ADDENDUM NO. 2

**RE: Boone County Public Library
Hebron Branch
North Bend Road
Hebron, Kentucky 41048
Project No. 16064**

**FROM: Brandstetter Carroll Inc.
2360 Chauvin Drive
Lexington, Kentucky 40517
Phone 859-268-1933
Fax 859-268-3341**

October 6, 2017

GRADING PLAN

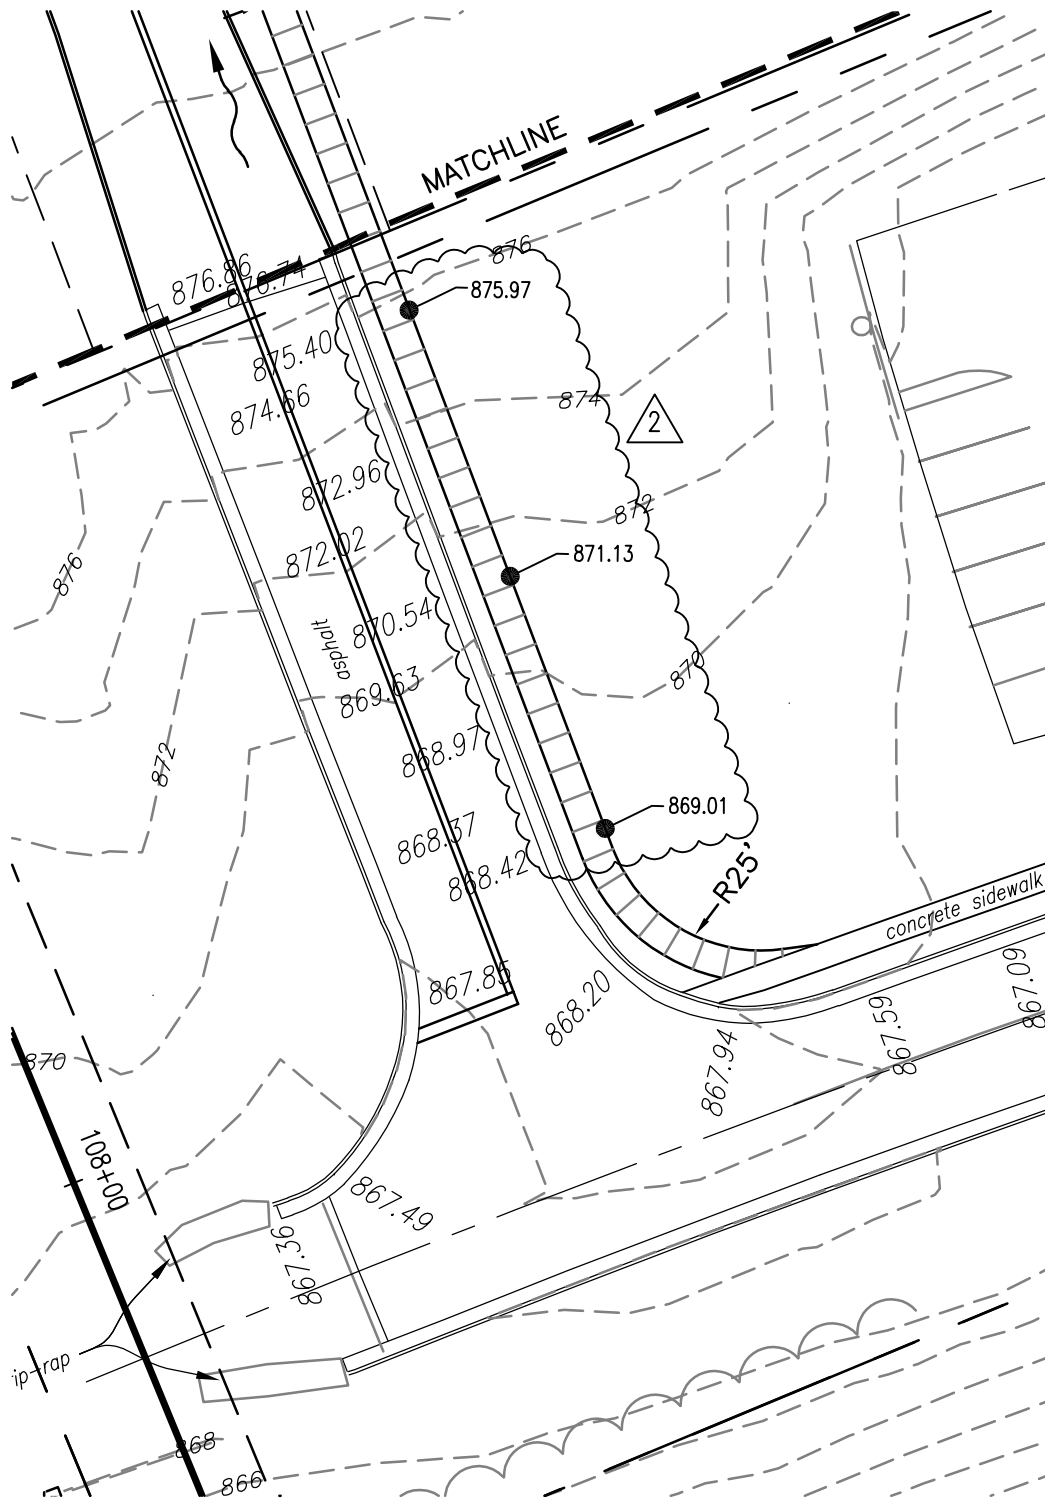
1. **C-103 Grading Plan**

A. Refer to the enclosed sketch ADD 2.1 for additional information pertaining to the sidewalk along the south entrance drive.

EROSION CONTROL PLAN

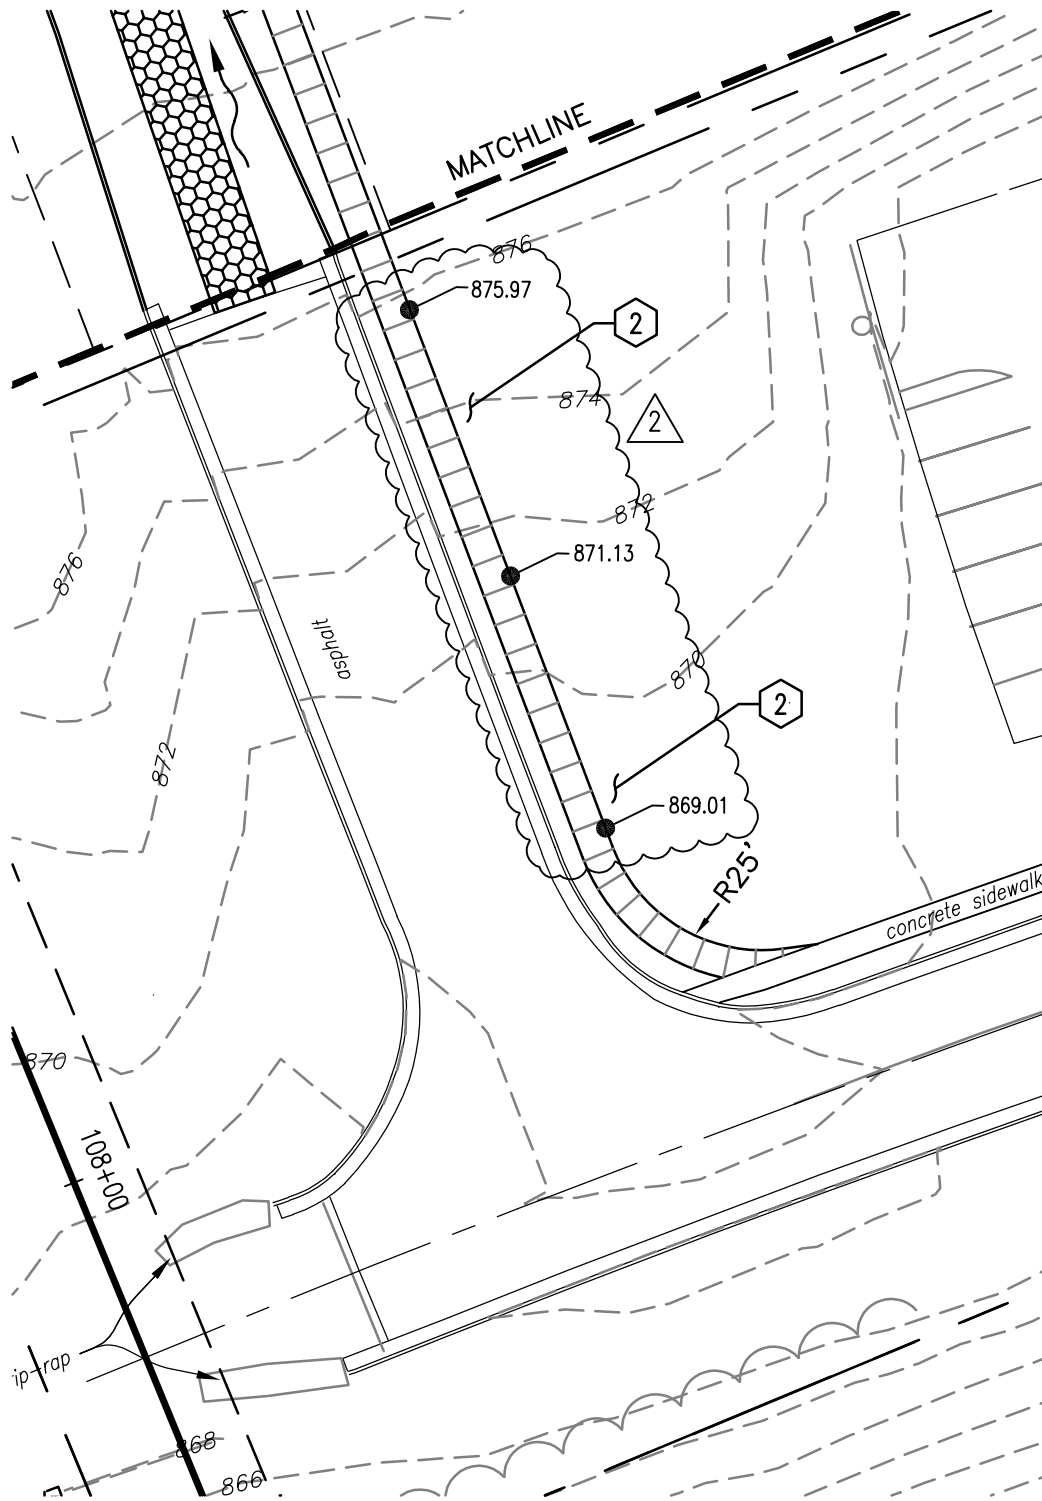
3. **C-105 Erosion Control Plan**

A. Refer to the enclosed sketch ADD 2.2 for additional information pertaining to the sidewalk along the south entrance drive.

HEAVY DUTY
(HATCH ON LAYOUT PLAN)

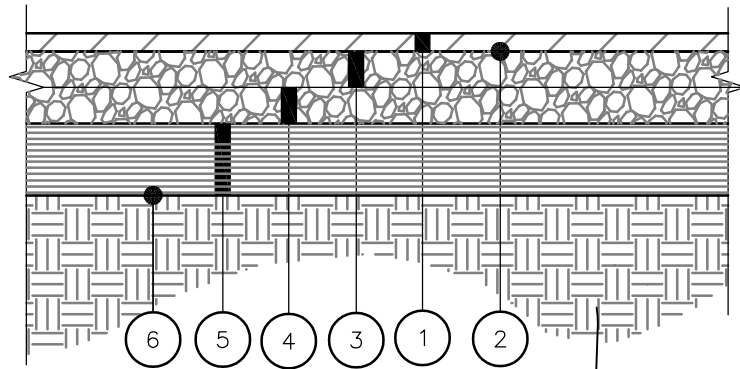
4. **C-501 Site Details**

- A. Refer to detail A3.
 - i. Bottom of Stop Sign shall be 5'-0" from the parking surface.
 - ii. Bottom of the Van Accessible Sign shall be 5'-0" from the parking surface.
- B. Disregard detail D5 and replace it with the enclosed sketch ADD 2.3.

B1 Foundation Plan
S-101 1/8" = 1'-0"

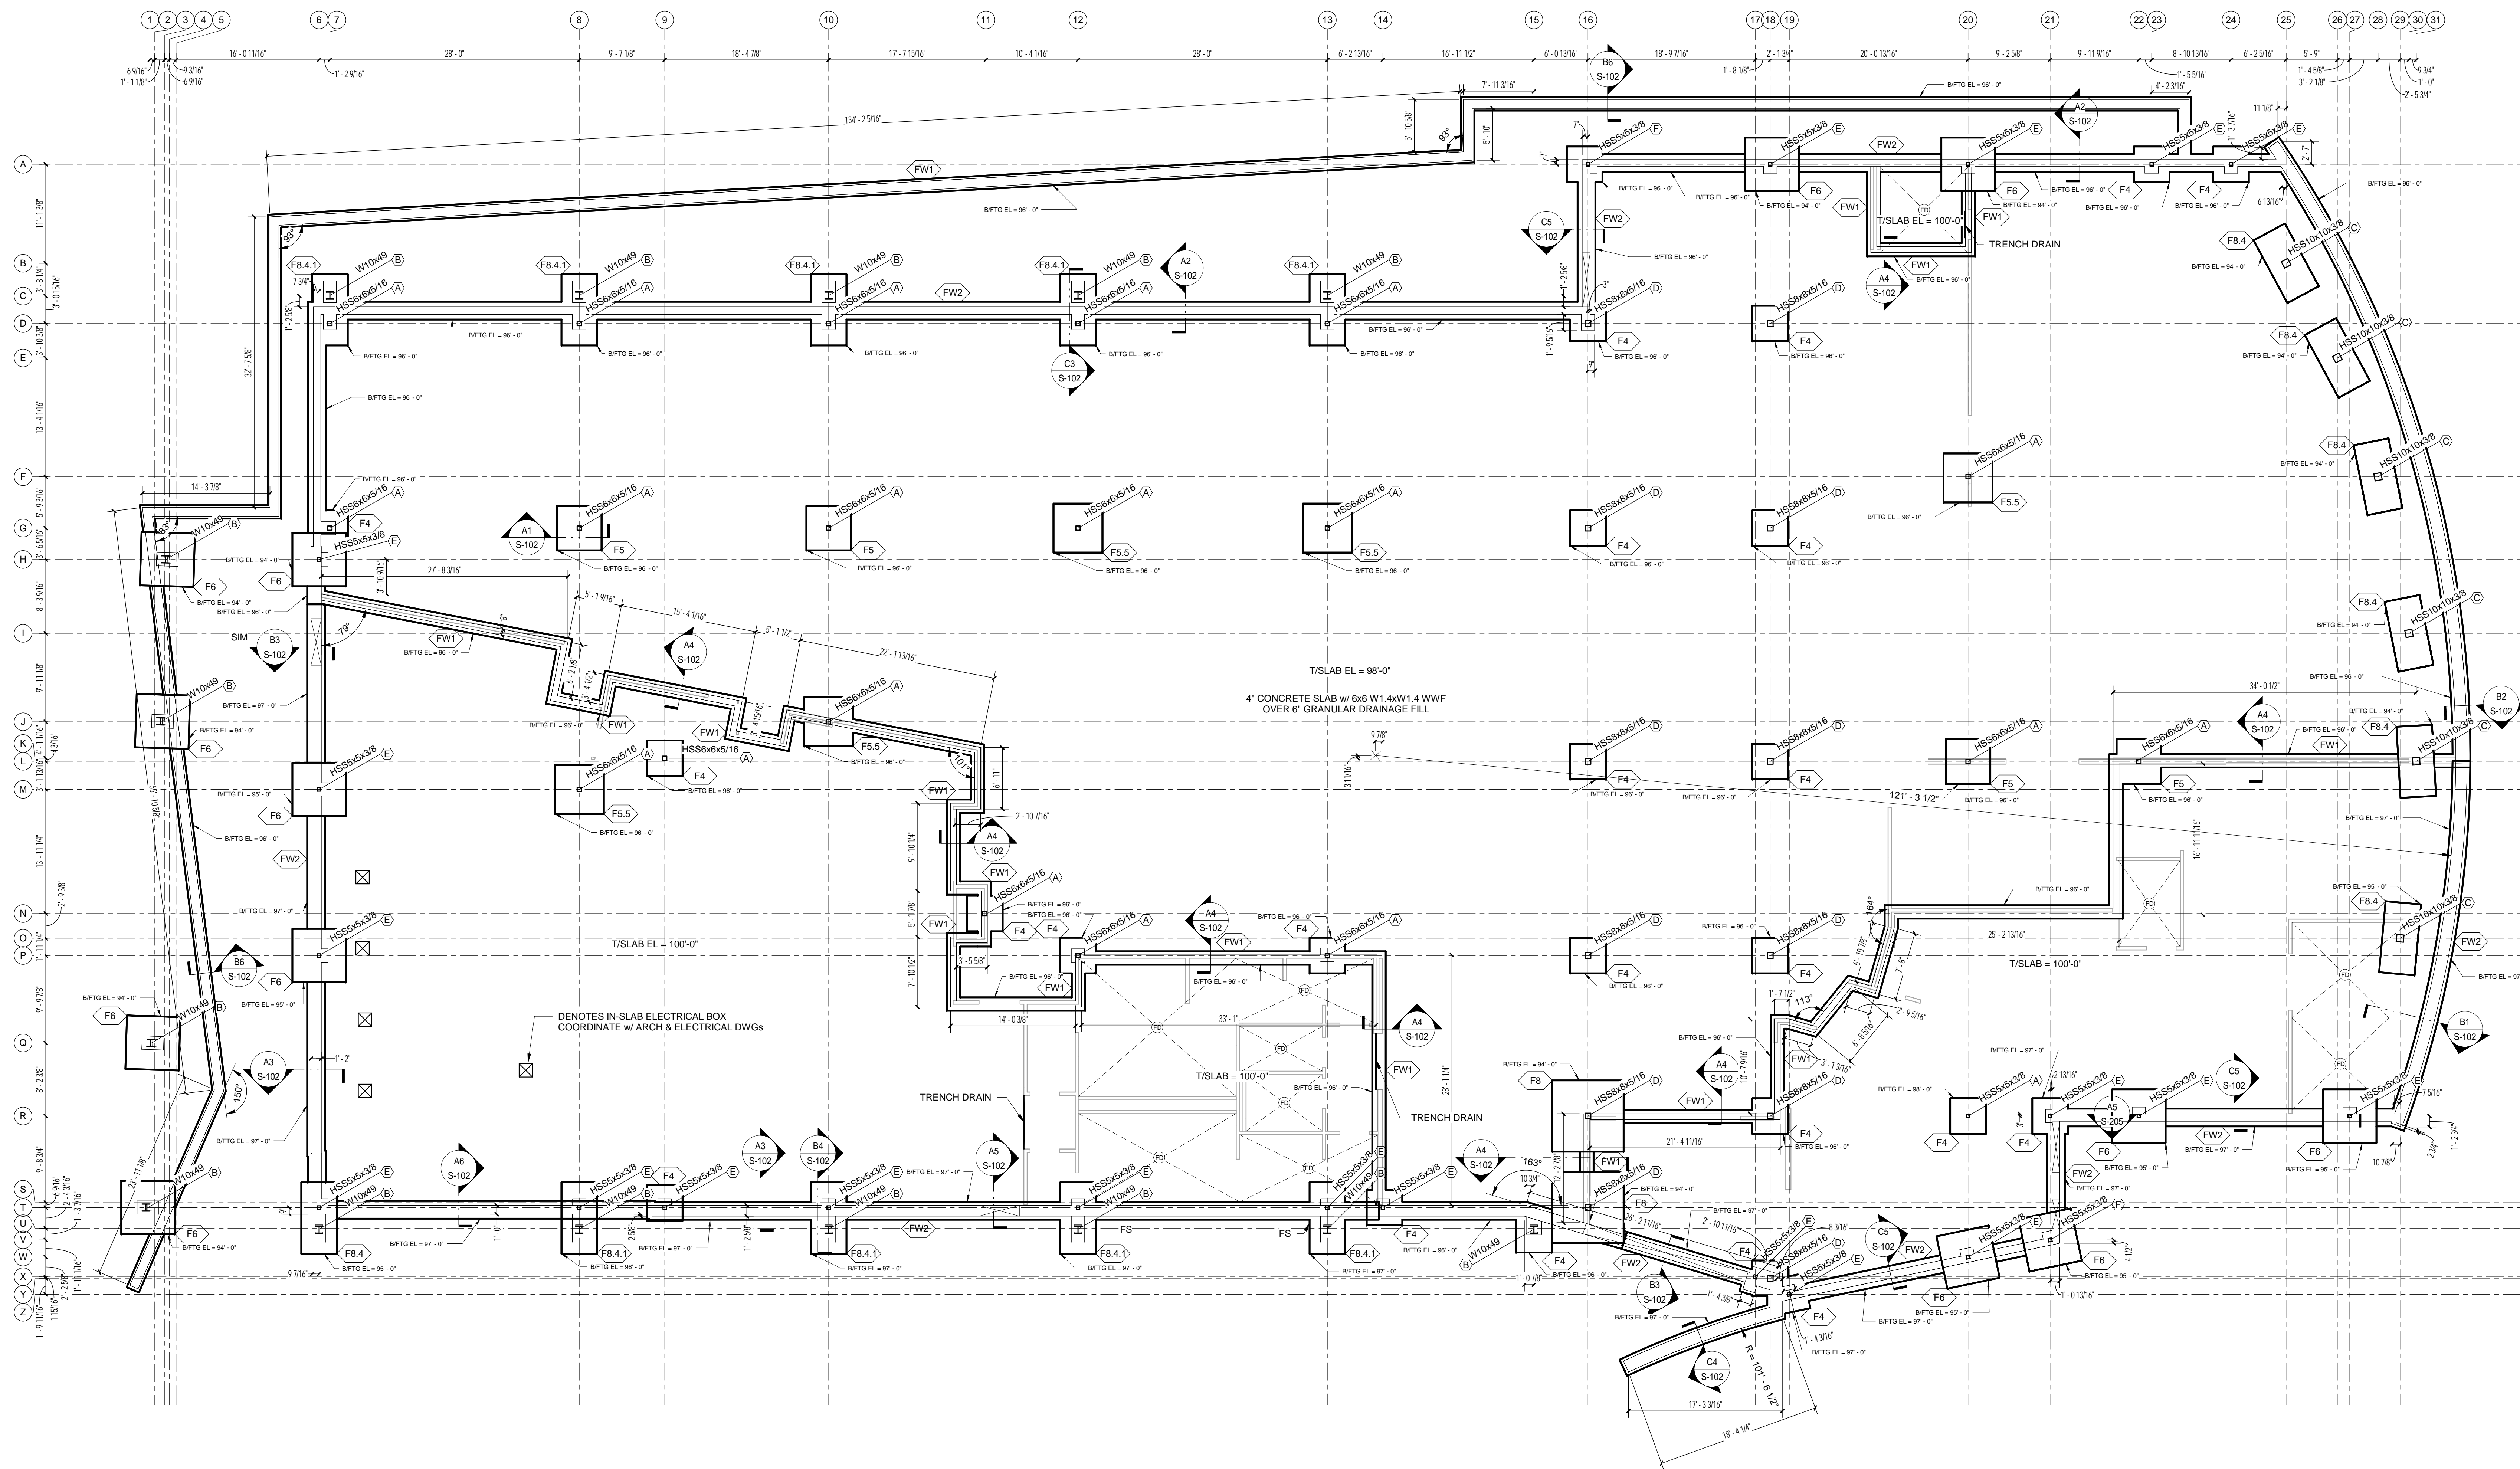
6. **S-101 Foundation Plan**

- A. Refer to attached full size sheet S-101. The original S-101 sheet shall be disregarded.
- B. Column footings at C7, C8, C10, C12, C13, T8, T10, T12 and T13 shall have 8'-0"x4'-0"x1'-0" deep footings with reinforcing as shown on the footing schedule.
- C. Column footings on lines 1, 2, 3 and 4 are to be included in Alternate #6. These column footings will not be installed if the alternate is not accepted. If the alternate is not accepted the concrete slab on grade at that location will be a 5'-0" wide walkway along the exterior of the building but will still have a footing and foundation wall as shown in section B6/S-102.
